North Dakota Department of Transportation
INVITATION TO BID

NDDOT Contract # 50161771

Bid Number: 760-06-16-050	Bid Opening Date & Time: 08/10/2016 02:00 PM
Items: Cutting Edges	Buyer: Vanessa Brosten
Bid Mailing Address: 608 East Boulevard Avenue	Telephone Number: 701-328-4466
City, State, Zip: Bismarck, North Dakota, 58505	Email: vbrosten@nd.gov
Contract Period: 08/15/2016 TO 07/31/2017	Date Prepared: 07/22/2016

Amendment No. 1

ATTACHMENT C

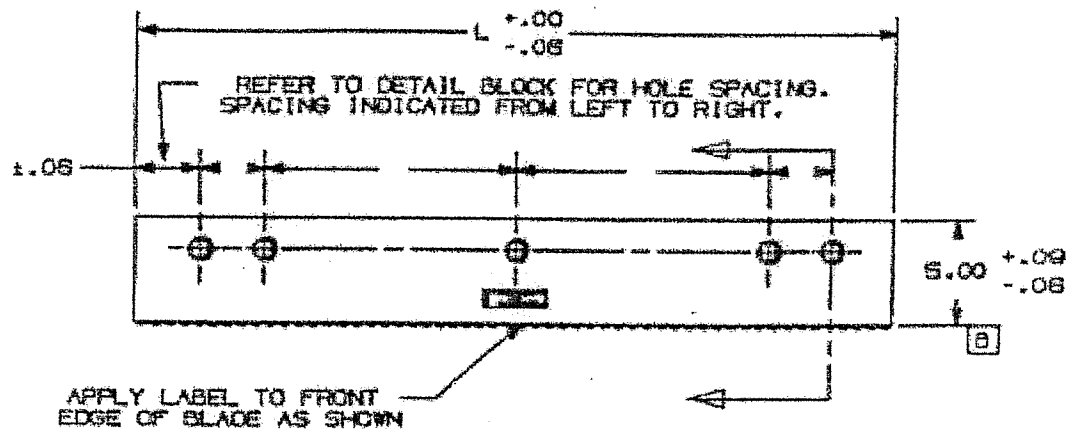
Your attached drawing (attachment C) does not show a side view, so we are questioning whether you need these blades with a square top or a beveled top.

Delete Attachment C of the bid document and replace with the attached 4 drawings.
